The Commission has issued the enclosed Amendment No. 17 to Facility Operating License No. DPR-31 and Amendment No. 16 to Facility Operating License No. DPR-41 for Turkey Point Nuclear Generating Units 3 and 4. These amendments are in response to your request dated February 25, 1976, and Supplements dated February 25, April 21, May 10, May 13, and May 19, 1976.

TURKEY POINT NUCLEAR GENERATING UNIT 3

Amendment No. 17  
License No. DPR-31

Amendment No. 16  
License No. DPR-41

FIGURE 3.2-1

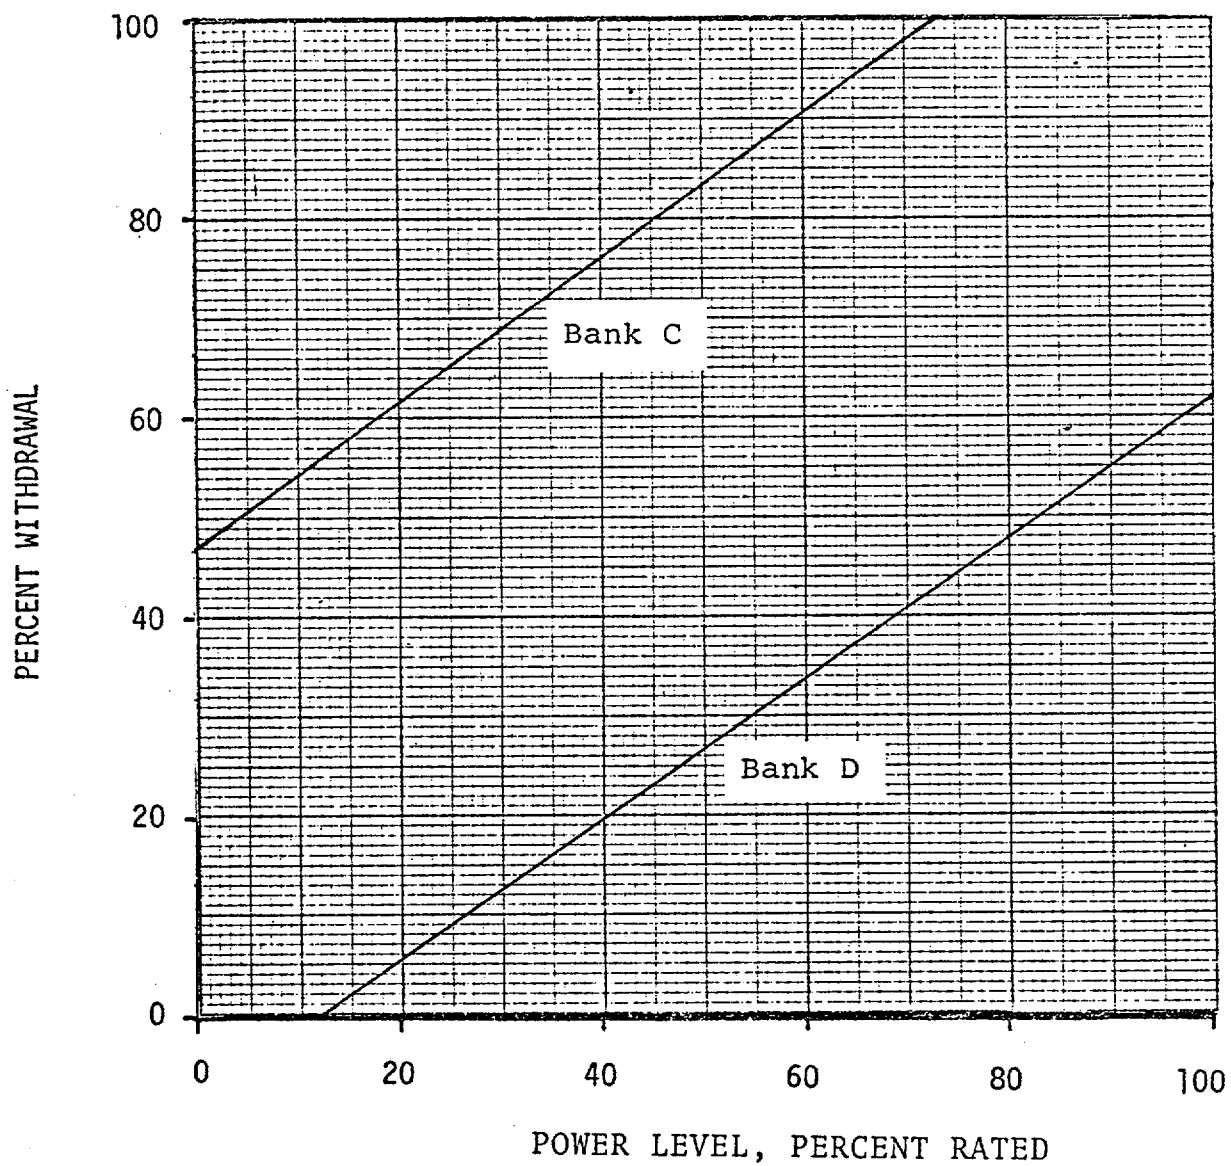
- a. Whenever the reactor is critical, except for physics tests and control rod exercises, the shutdown control rods shall be fully withdrawn.
- b. For Unit 4, whenever the reactor is critical, except for physics tests and control rod exercises, the control group rods shall be no further inserted than the limits shown on Figure 3.2-1 for three loop operation and on Figure 3.2-1(a) for two loop operation.

- d. The Unit 4 control rod insertion limits shown on Figure 3.2-1 and the Unit 3 control rod insertion limits shown on Figure 3.2-1(b) may be revised on the basis of physics calculations and physics data obtained during startup and subsequent operation.

FIGURE 3.2-1

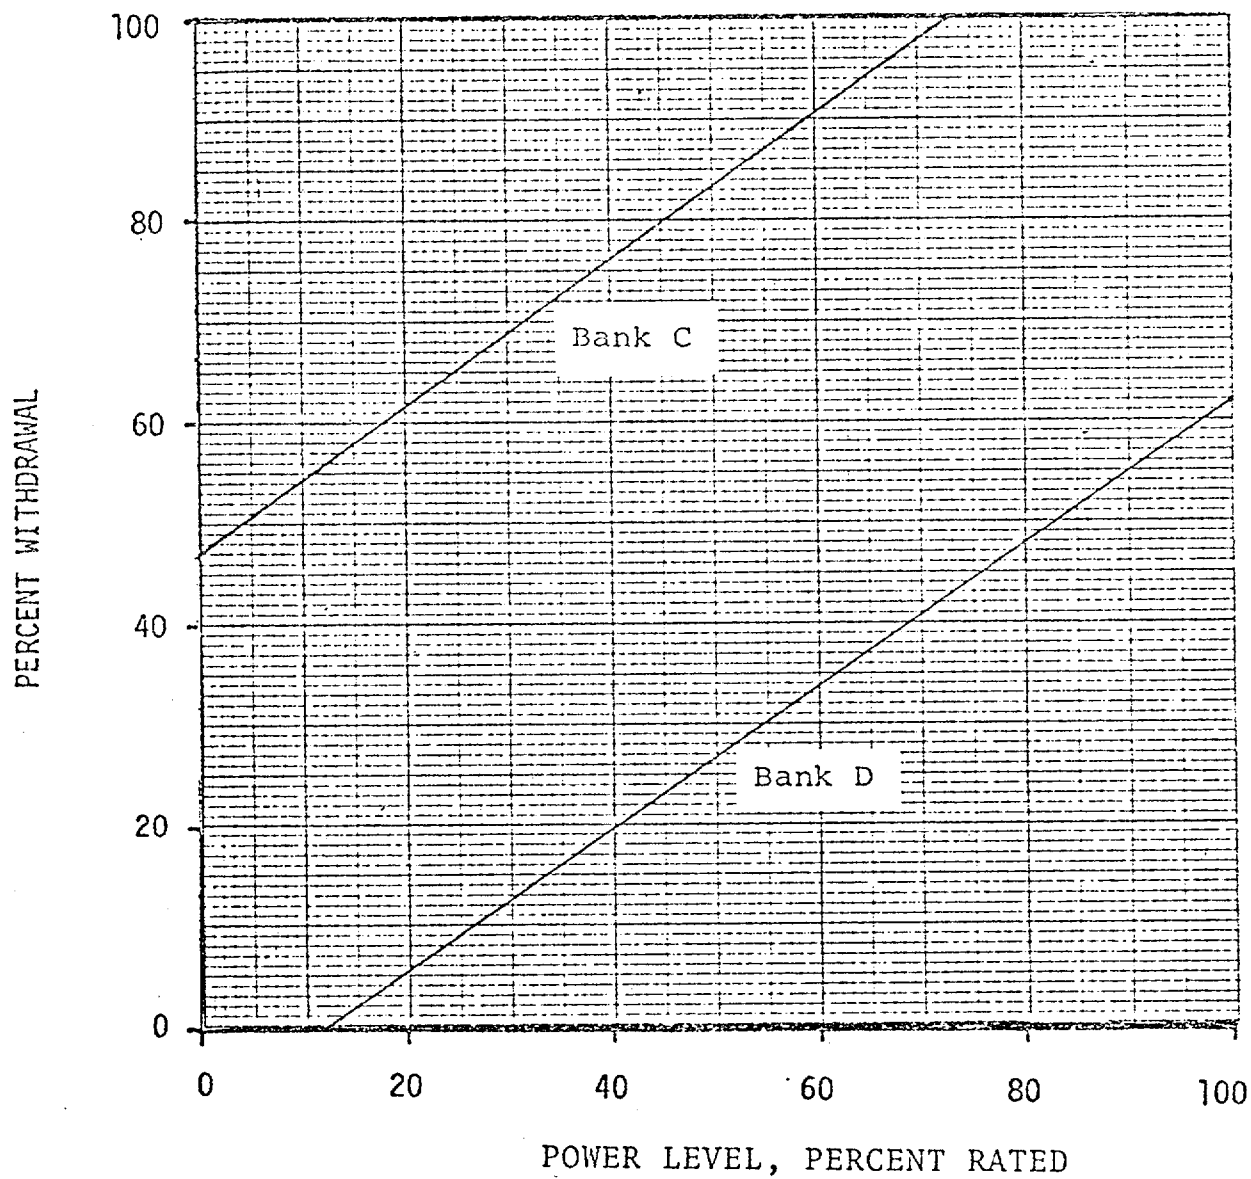
- a. Whenever the reactor is critical, except for physics tests and control rod exercises, the shutdown control rods shall be fully withdrawn.
- b. For Unit 4, whenever the reactor is critical, except for physics tests and control rod exercises, the control group rods shall be no further inserted than the limits shown on Figure 3.2-1 for three loop operation and on Figure 3.2-1(a) for two loop operation.

- d. The Unit 4 control rod insertion limits shown on Figure 3.2-1 and the Unit 3 control rod insertion limits shown on Figure 3.2-1(b) may be revised on the basis of physics calculations and physics data obtained during startup and subsequent operation.

The proposed control rod insertion limits allow the control rods to be inserted into the reactor core a smaller amount in core Cycle 3 than they were in core Cycle 2. A decrease in the amount of allowed insertion is conservative and increases the minimum available shutdown margin, maintains an acceptable core power distribution, decreases the consequences of a control rod ejection accident and decreases the consequences of control rod misalignment. Moreover, since we find that the use of the proposed control rod insertion limits will not effect previously performed applicable safety analyses, we conclude that the proposed insertion limits are acceptable.

FIGURE 3.2-1(a)

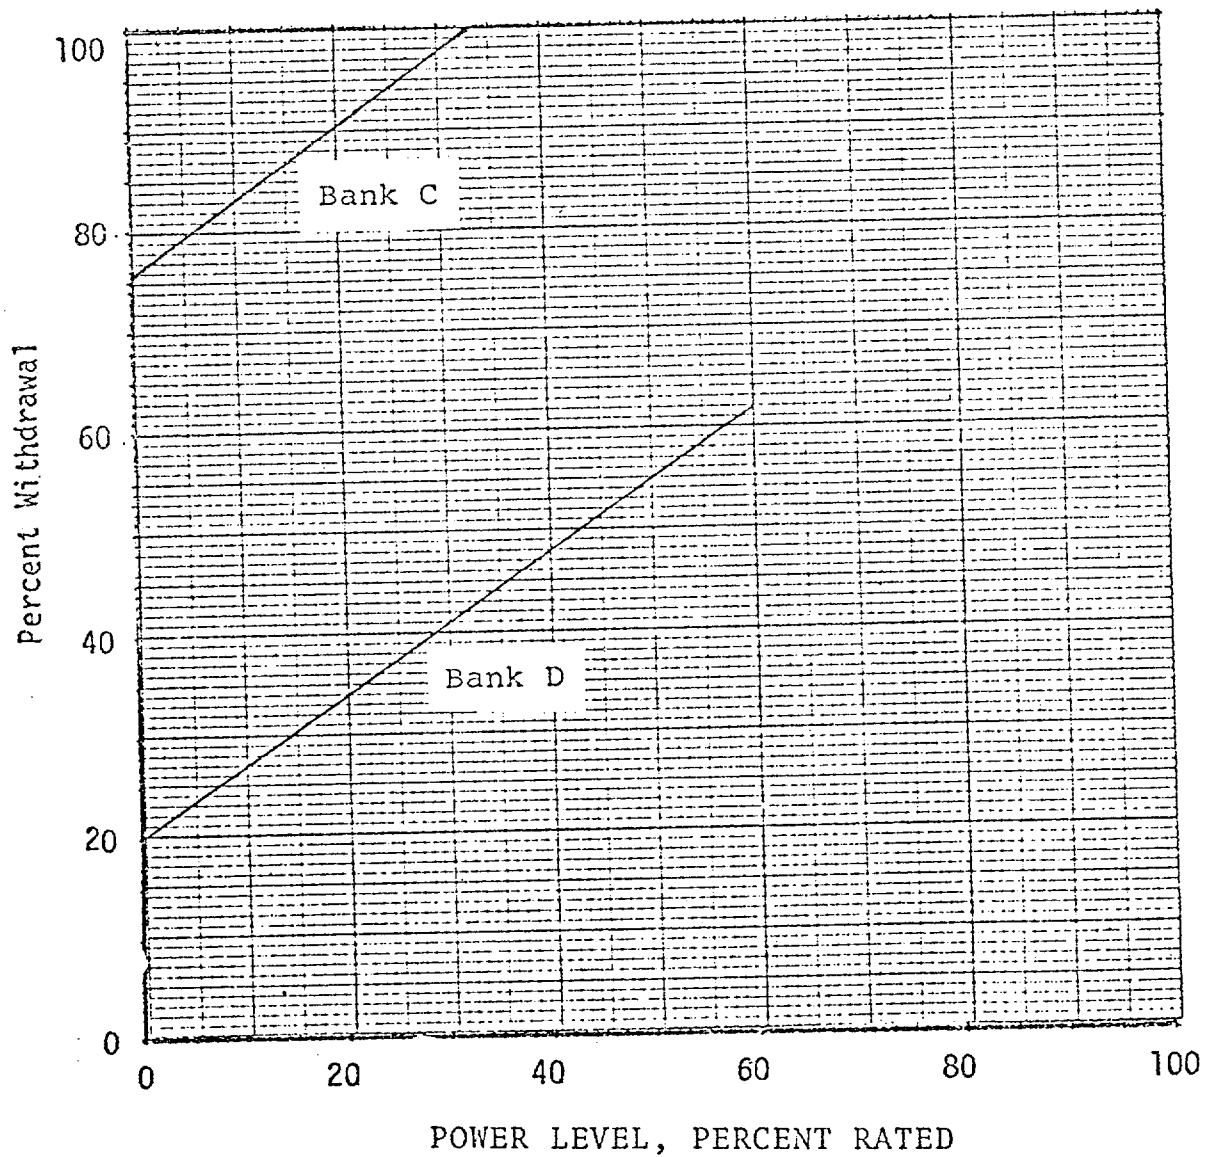
The proposed control rod insertion limits are the result of analyses performed for the Unit No. 4 Cycle 3 core configuration to insure: (1) an adequate shutdown margin is maintained throughout cycle life, (2) hot channel factors are maintained below design limits, (3) acceptable consequences of a rod ejection accident, and (4) acceptable consequences of rod misalignment. The maintenance of adequate shutdown margin at the end of core life is the consideration which defined the proposed control rod insertion limits for reactor operation with three reactor coolant pumps operating. When two reactor coolant pumps are operating the reactor coolant flow is reduced and the reactor coolant inlet temperature is increased. These changes in operating conditions are sufficient to make the maintenance of an acceptable hot channel factor the consideration which defined the proposed control rod insertion limits for reactor operation with two reactor coolant pumps operating.
